ASSESSMENT REPORT

Mangoola Coal Mine Section 75W Modification

Figure 2: Location of Approved and Proposed MIA Facilities, including the CHPP

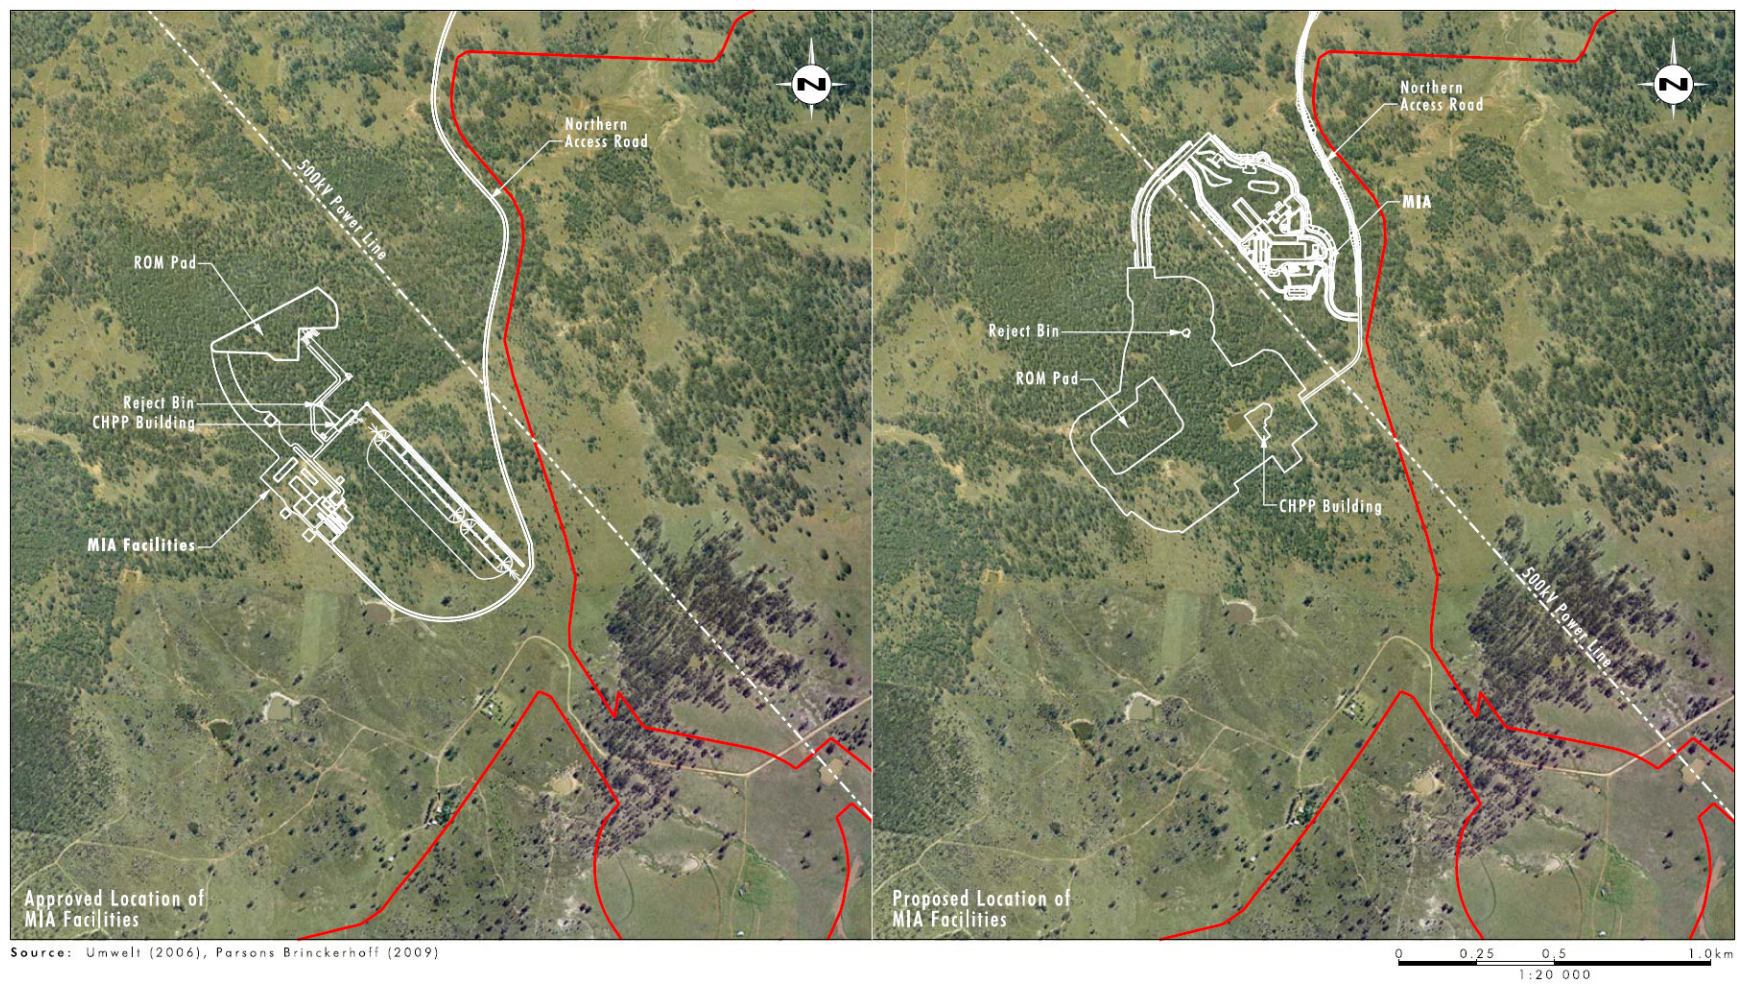
Xstrata proposes to relocate the Mining Infrastructure Area (MIA) approximately 1km north-north-east (NNE) of the approved location, see Figure 2. The relocated MIA would be contained within the approved project disturbance boundary; however the base level of the MIA facilities would be approximately 10 metres higher than the approved levels.

- change the orientation of the CHPP building from NE-SW to NW-SE;
- change the position of the ROM stockpile pad, moving it 100 metres to the south; and
- change in base levels resulting in an increase in the height of the reject bin by 3 metres.

Figure 3: Visual Assessment Locations & Vegetation Screen

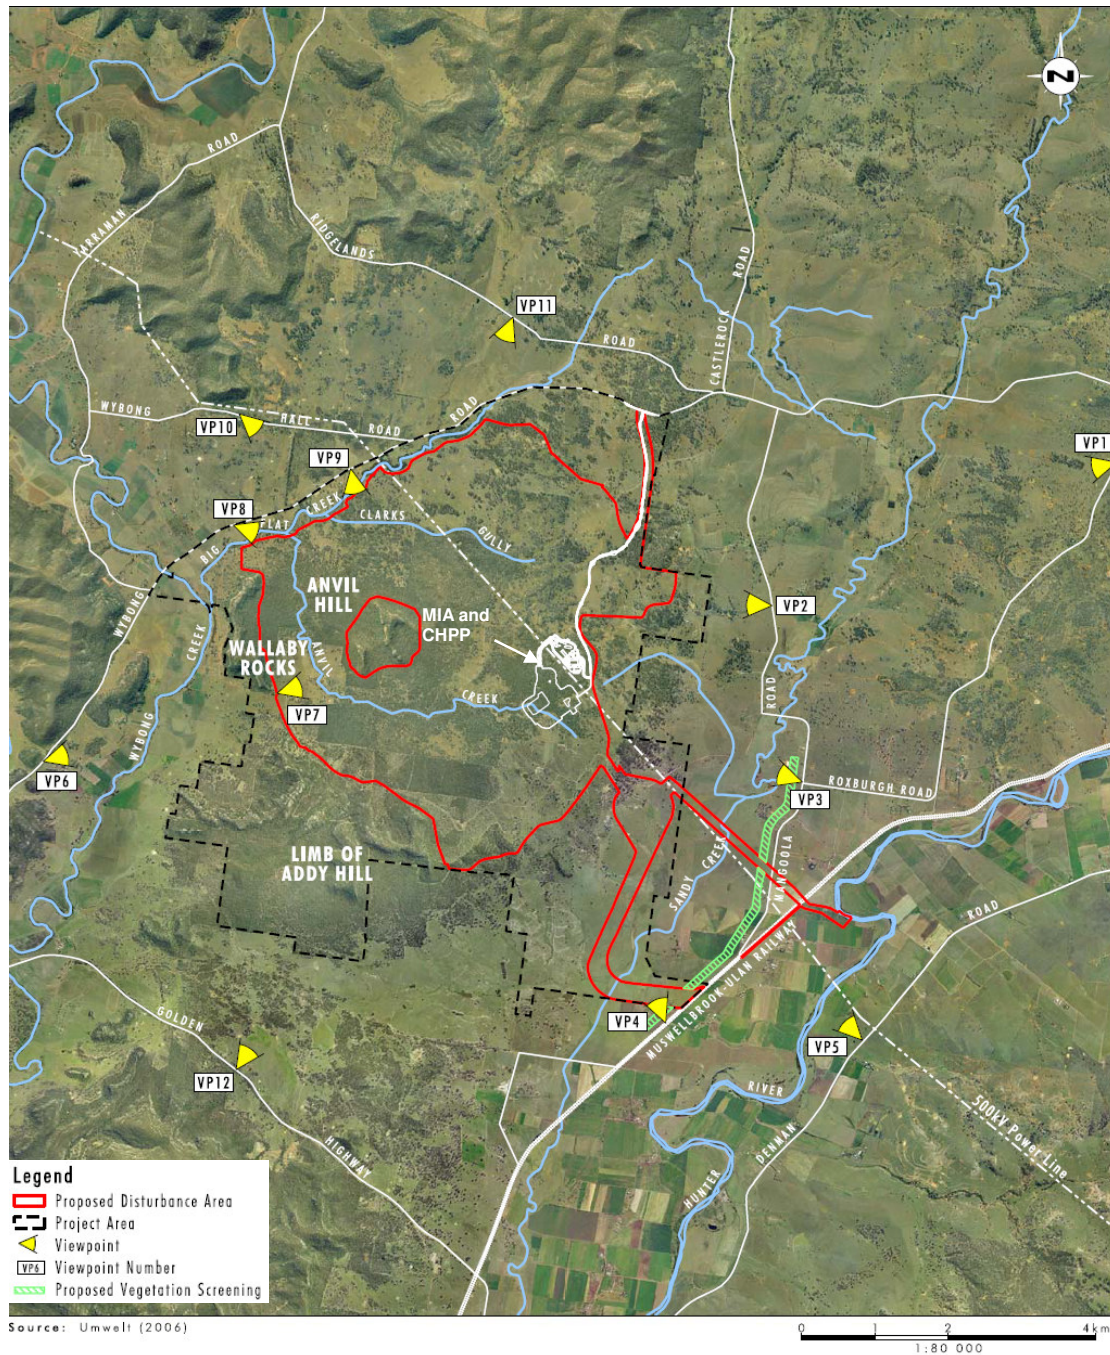
The visual assessment considered views from the same points as those assessed in the original Environmental Assessment (EA) and determined view points (VP) 1, 2, 3 and 4 to be the most affected, see Figure 3. These view points are located to the north-east, east and south of the proposed MIA and CHPP facilities and represent views from Mangoola and Roxburgh Roads.

The visual assessment concluded that the proposed location of the MIA, 1km NNE of the approved location remains within a moderate-high scenic quality zone as defined in the original EA. The assessment determined that there would be no change to the visual impact rating of VP1, 2 and 4. The rating at VP3 would change from moderate to moderate-high impact due to the MIA moving to the eastern edge of the ridgeline. VP3 represents the views experienced by traffic passing through the intersection of Mangoola and Roxburgh Roads. No private residences are located at this view point, with the nearest being over 1km to the east.

The assessment also considered the extent of screening vegetation between the MIA and the key view points. The assessment concluded that insufficient vegetation would remain on the eastern and southern slopes below the MIA to screen it from viewers at VP2, 3 and 4. Therefore, Xstrata has commenced planting a rapid growing vegetation screen along the western edge of Mangoola Road from the northern side of VP3 through to VP4 (see Figure 3). Vegetation has been planted between VP3 and VP4, with the section to the north of VP3 yet to be planted. This northern section is subject to a Ground Disturbance Permit procedure requiring Aboriginal stakeholder consultation prior to undertaking planting. Once mature, the vegetation would provide a reasonable level of screening of the MIA when viewed from Mangoola Road between VP3 and VP4.

The Department considers that the revised visual impacts at VP3, increasing from moderate to moderate-high, would have only a minor impact, given that there are no private residences in this location and the views to be affected are from passing traffic. The proposed vegetation screen from VP3 to 4 would, in time, minimise these impacts. The Department has recommended a condition requiring Xstrata to complete this planting early, to provide the maximum time for the vegetation to mature. As the section north of VP3 is subject to stakeholder consultation, and to avoid planting during the hottest months, the Department requires Xstrata to complete the planting no later than July 2010.

Figure 4: Residence Locations used for Noise Assessment

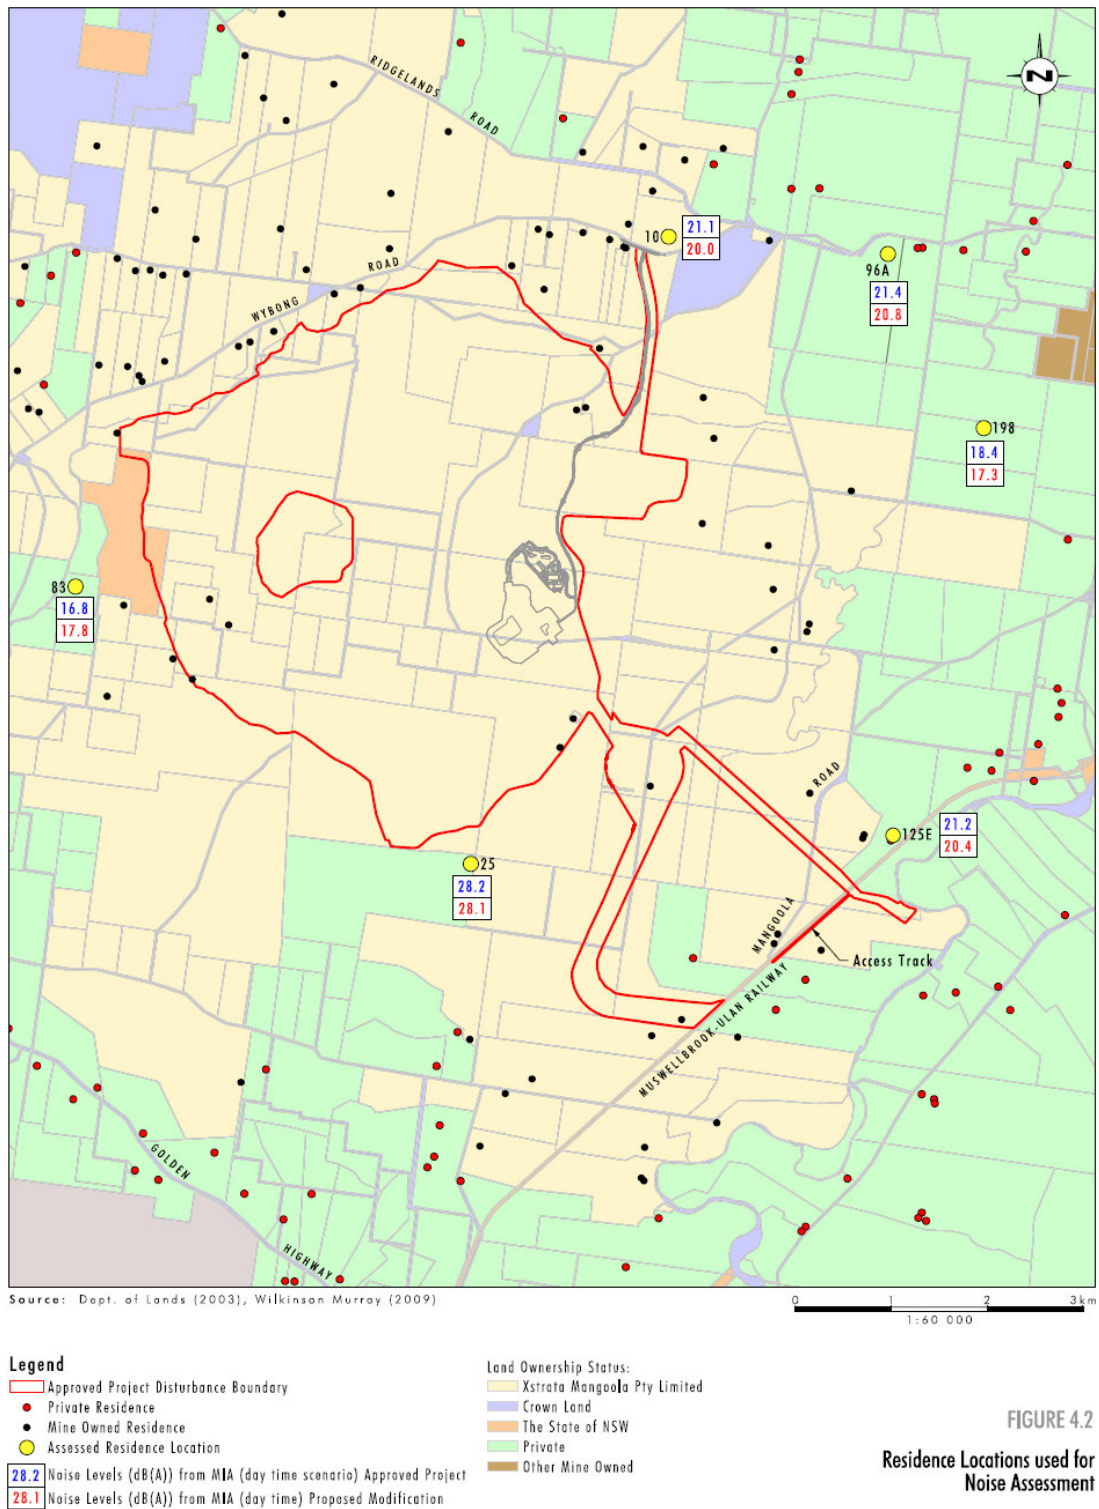
A noise assessment of the proposed modification was undertaken by Wilkinson Murray Pty Ltd. The assessment predicted noise level changes at six residences most likely to be impacted by the relocation of the MIA. These residences are shown on Figure 4. The results of the assessment are shown in Table 1 and summarised below.

The MIA is proposed to be relocated 1km to the NNE of the approved location. Residence number 83, located approximately 4.8km to the west is identified as the nearest residence to be impacted by increased noise due to the modification, albeit only a minor increase of 1dB(A). All other nearest residences to the north, north-east, south-east and south are predicted to experience a minor reduction in noise as a result of the modification.

The Department is satisfied with the level of additional noise assessment undertaken for the modification and considers that the predicted impacts would be negligible. No amendment to the conditions for managing noise impacts is considered warranted.
